**Re: W14a-b, Application Nos. 4-23-0791 and 4-25-0159 (City of Ventura, Surfer's Point)**

**Circles depict City-owned assets where retreat could be most easily integrated into a long-term plan**

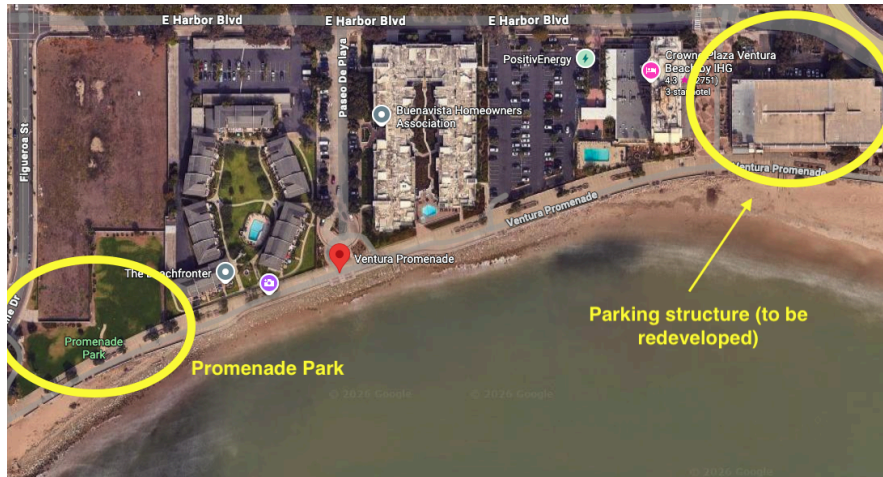
We offer the following observations regarding opportunities for adaptation that both the long-term hazards management plan and the BMAP should examine. The promenade in this area is mostly backed by private structures, limiting the City's and Commission's direct influence. However, the parking structure and Promenade Park flanking this CDP site are city-owned assets. The City is actively seeking to redevelop the parking structure site, and that redevelopment should include setbacks sufficient to accommodate realignment of the promenade and prevent further beach loss. Proposals [received](#) to date (all large hotel complexes with no additional setbacks apparent) appear to fall short in that regard. Promenade Park similarly affords space for landward migration. Unlike the beach, and to a lesser degree the promenade itself, the grassy park is not a coastal-dependent resource, and the Coastal Act prioritizes coastal-dependent uses. The property lines of the adjacent hotel and multiunit complexes should also be examined for potential realignment opportunities. Even the promenade itself – which is far wider than most beach boardwalks in Southern California – could be narrowed where necessary to recover beach space.
